SUBJECT: Amendment No. 5 to RFP 11-17 Orient Road Re-Entry Building Roof Replacement

PROJECT: HCSO Re- Entry Center Roof Renovation
PROJECT NUMBER: 1715-00 / 04-07
ADDENDUM NO.: Five (05)
ADDENDUM DATE: 12/04/17

HILLSBOROUGH COUNTY SHERIFF'S OFFICE
RE-ENTRY CENTER ROOF RENOVATION

A1.0

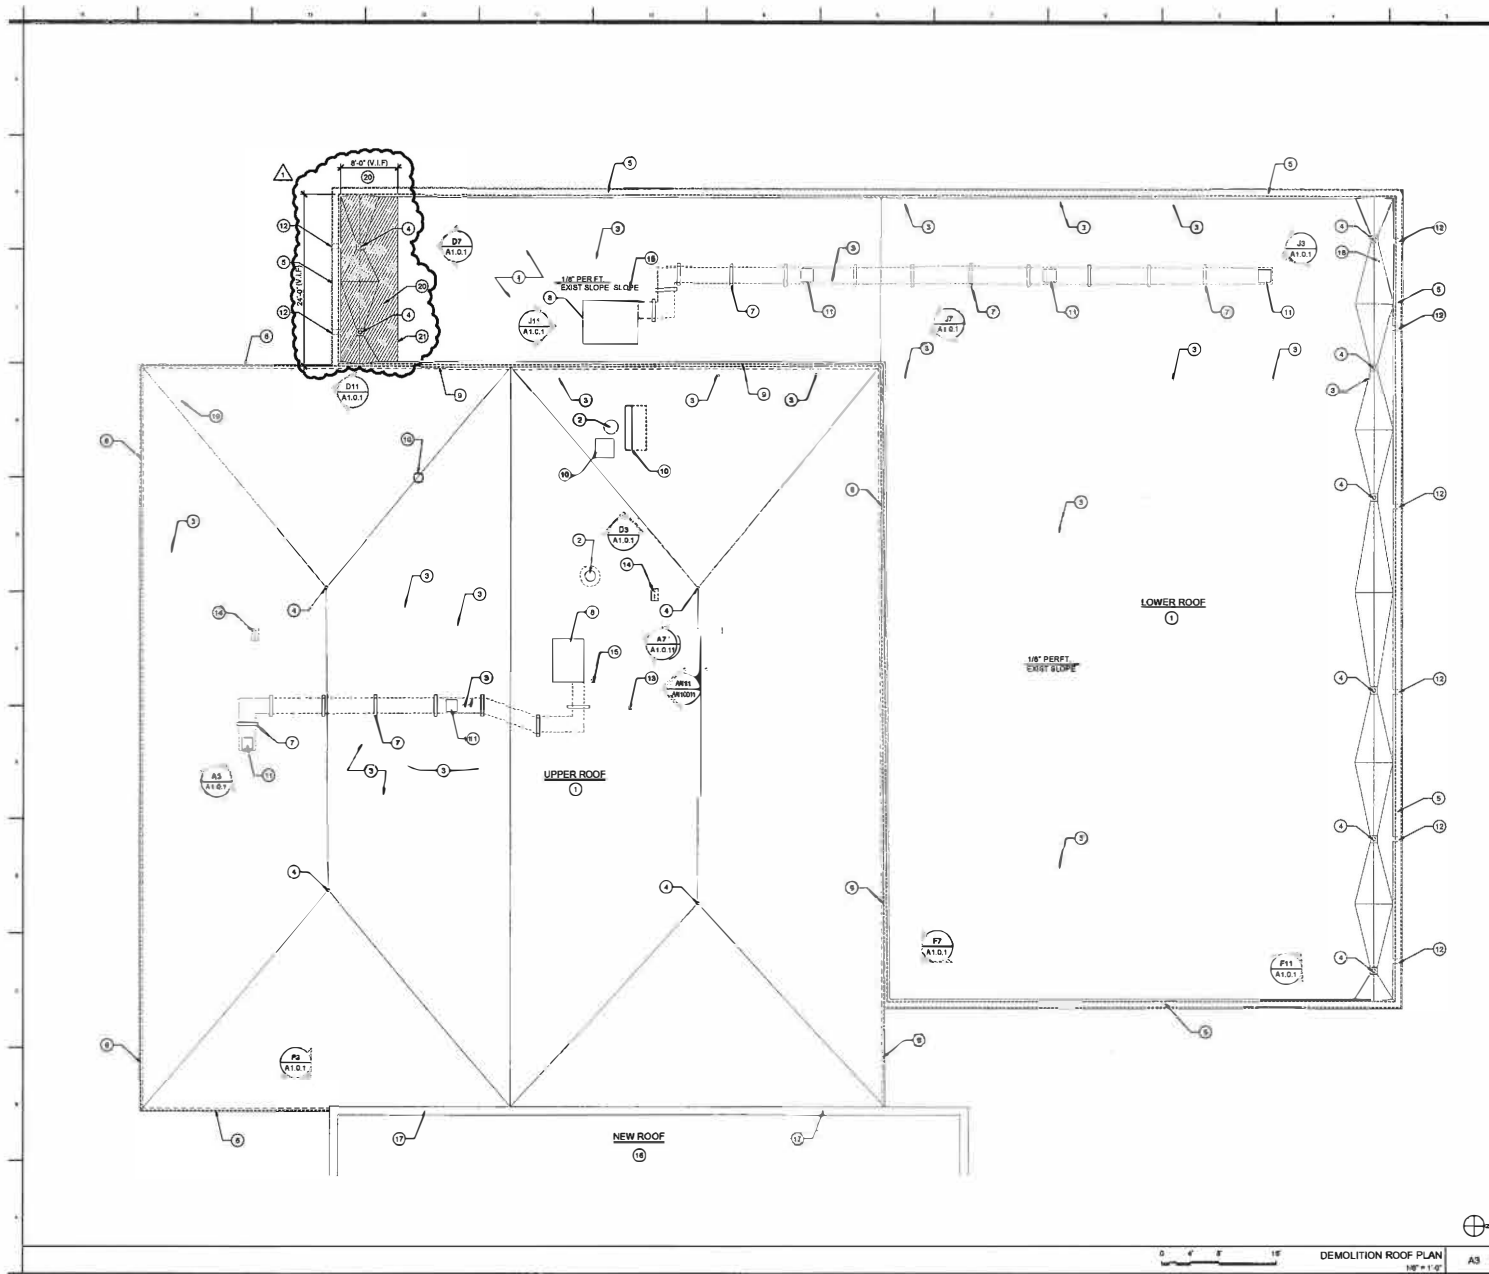
1. Sheet No.: A1.0
 - A. Revise sheet to include the removal of portion of existing insulation.
 - B. Specific Notes- Revise Specific Notes to include notes 20 and 21.
2. Sheet No.: A1.1
 - A. Revise sheet to include the installation of new insulation.
 - B. Specific Notes- Revise Specific Notes to include note 19.

18. CORE # LOCATION.
 19. REMOVE PORTION OF EXIST INSUL.
 20. LIMITS OF AREA REMOVAL.
